SUBJECT: NEW VEHICLE DEMONSTRATION / DELIVERY HOLD
Customer Satisfaction Program 20B14 – Supplement #2
Certain 2020 Model Year Escape Full Hybrid Electric Vehicle
Powertrain Control Module Update

New! REASON FOR THIS SUPPLEMENT

- *Updated Technical Information for Power Steering Control Module (PSCM) reset after PCM reprogram. Unplugging the PSCM is no longer required as new FDRS service function is available.*

FIGURE 1

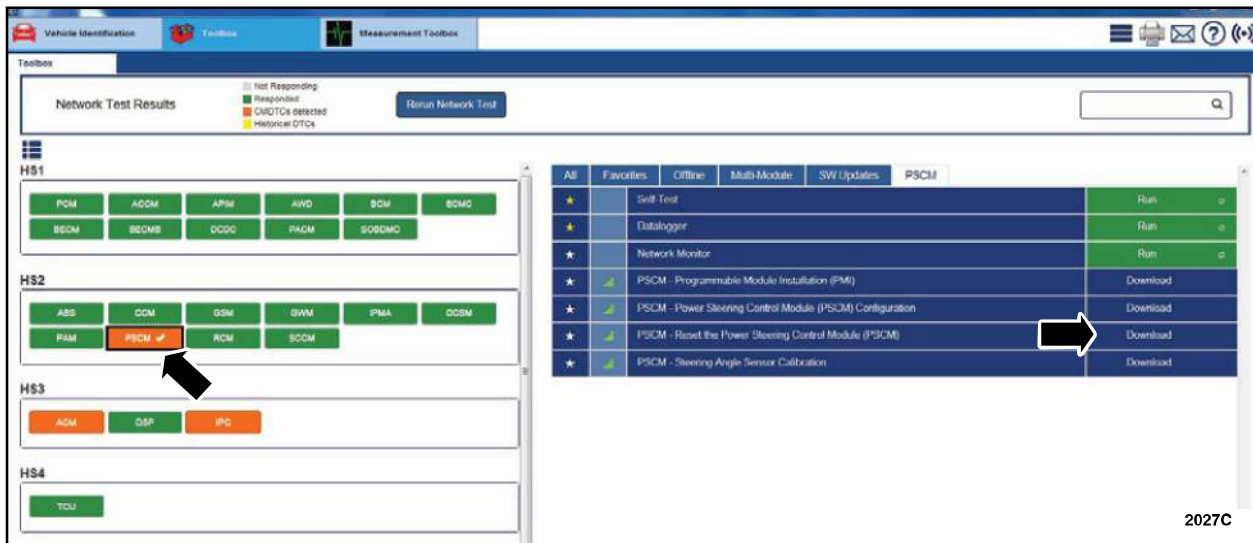
12. Under the tool box tab select "PSCM" and select download "PSCM - Reset the Power Steering Control module (PSCM)". See Figure 1. Select **Run** after the download.
